**NOTICE OF ADDENDUM -**

**CONTRACT NO. 7411**

MADISON WATER UTILITY, MADISON, WISCONSIN  
WATER SYSTEM IMPROVEMENTS  
BOOSTER PUMPING STATION 115 UPGRADE

**ENGINE GENERATOR PAD DETAIL**  
 NO SCALE

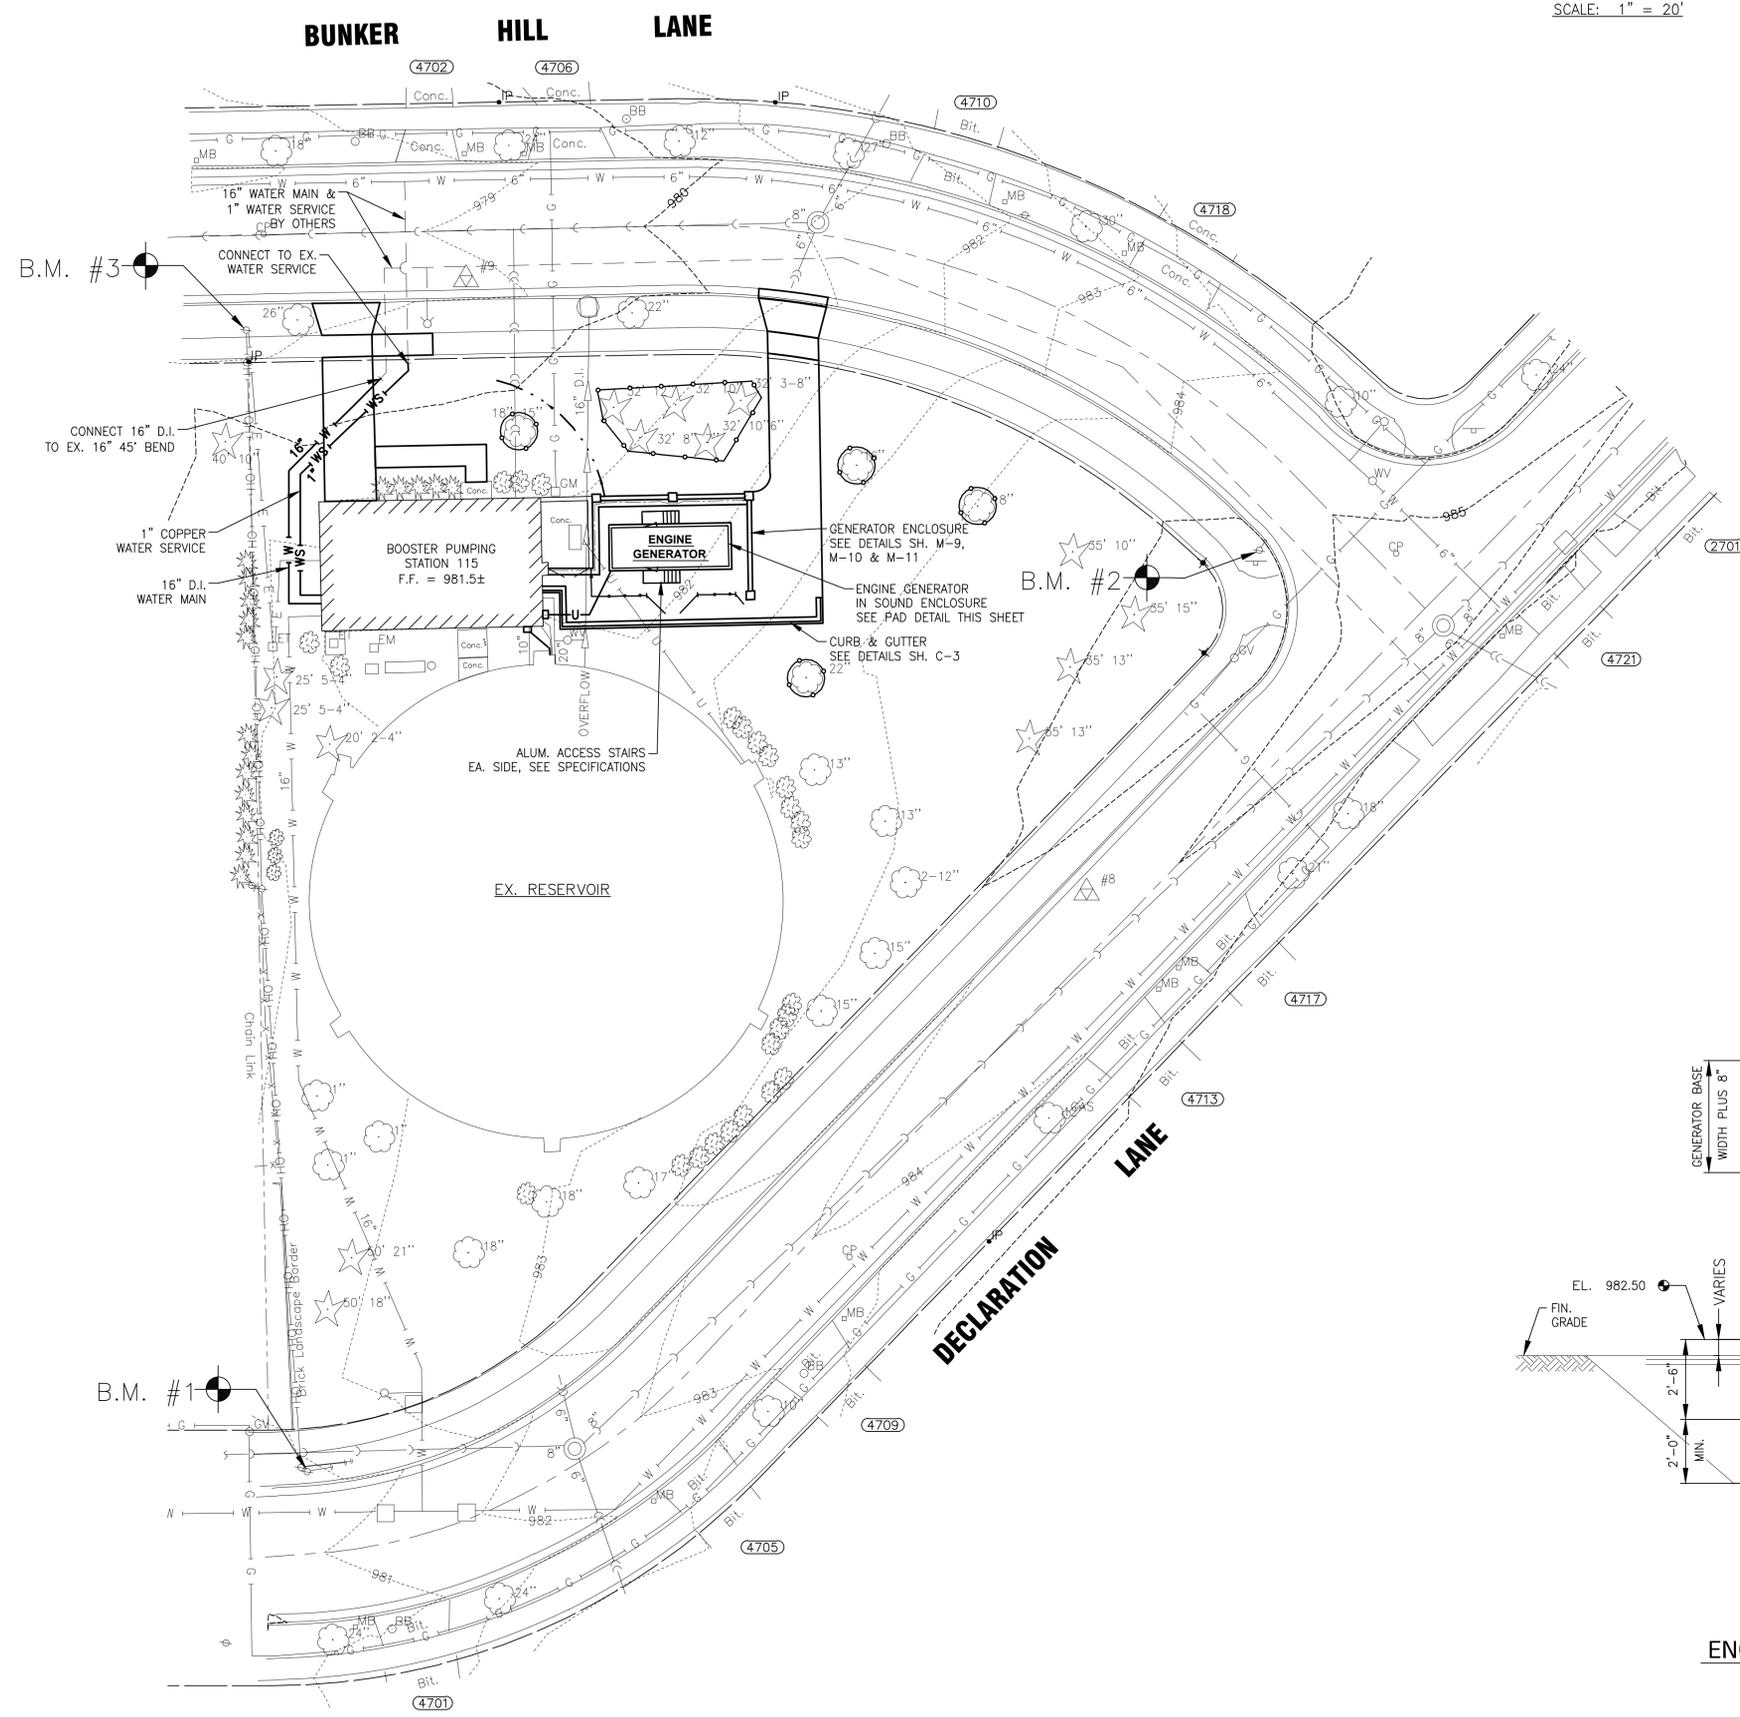
- A. Drawing C-2, Site Piping Plan
1. Change reinforcing for Engine Generator Pad as shown in revised Engine Generator Pad Detail, as noted on revised Drawing C-2 (attached to this addendum).
- B. Drawing M-9, Generator Enclosure Detail
1. Change reinforcing for footing walls and masonry wall as shown in revised Sections A and B, as note on revised Drawing M-9 (attached to this addendum).
- C. Drawing M-10, Generator Enclosure Details
1. Delete existing note 6 and replace with new notes 6 through 9 and Change reinforcing for footings and masonry walls as shown in revised Details 1, 2 and 3 as noted on revised Drawing M-10 (attached to this addendum).
- D. Drawing M-11, Generator Enclosure Exterior Elevations

**GENERATOR ENCLOSURE**  
**EXTERIOR ELEVATIONS**

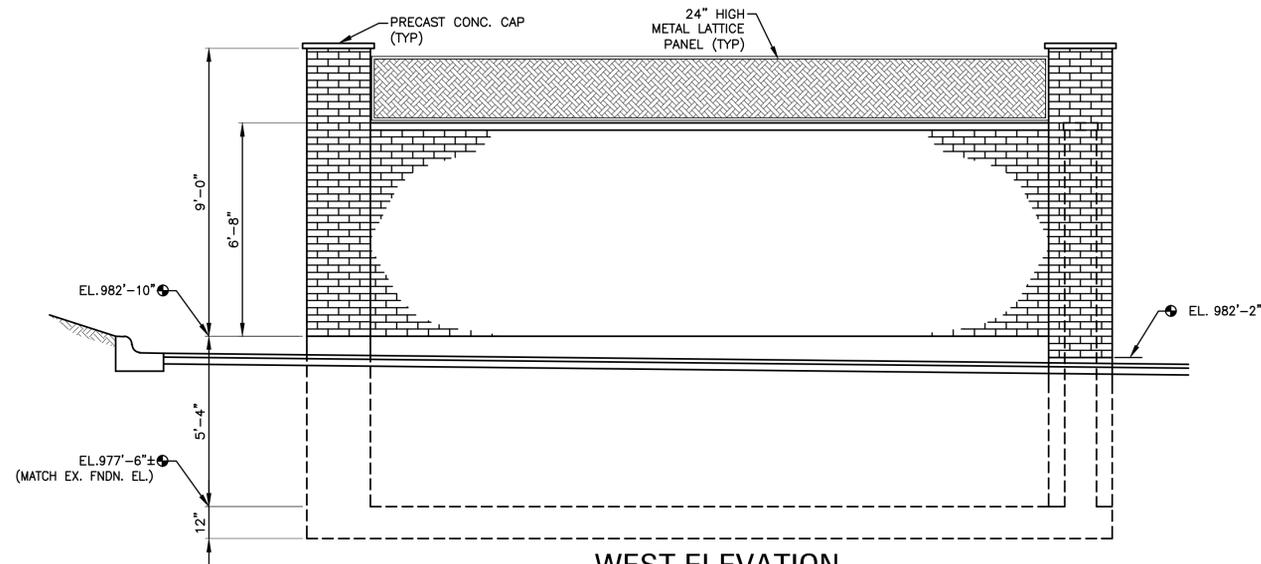
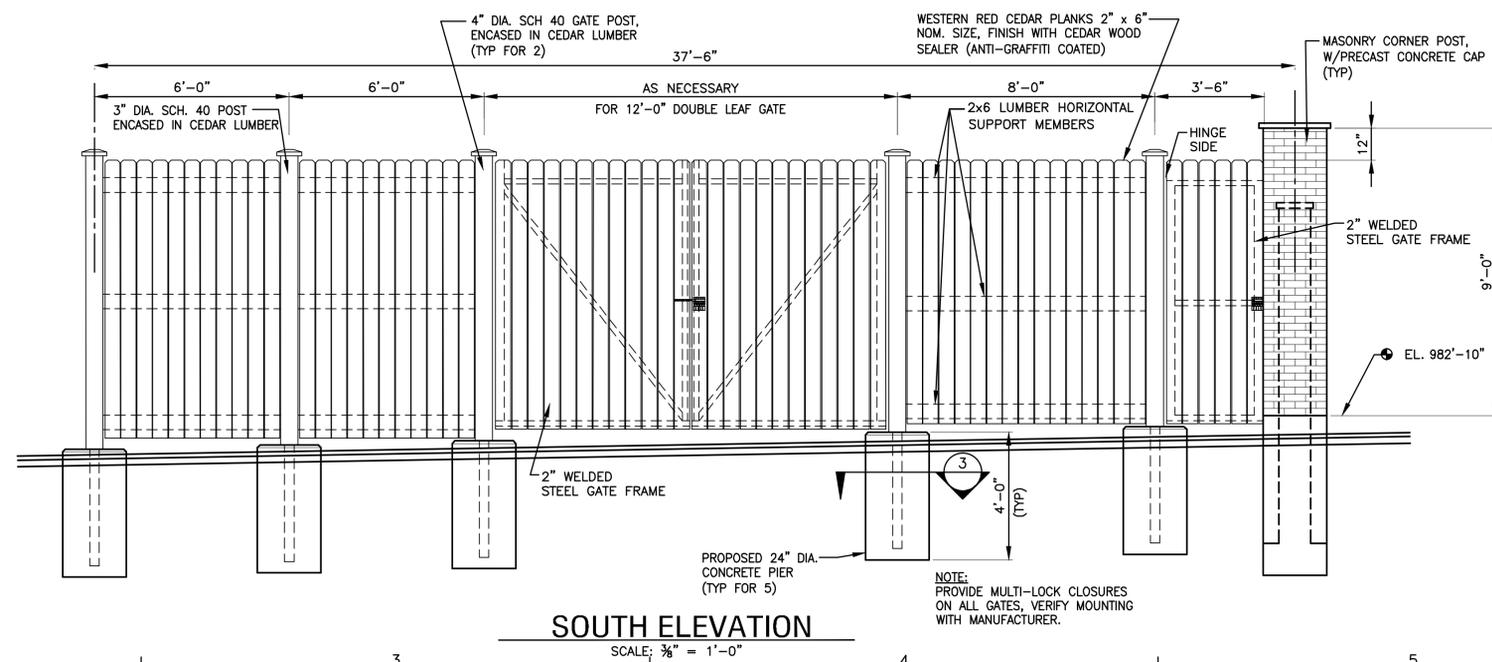
1. Change footing wall elevations as shown on North, West and South Elevations as noted on revised Drawing M-11 (attached to this addendum).
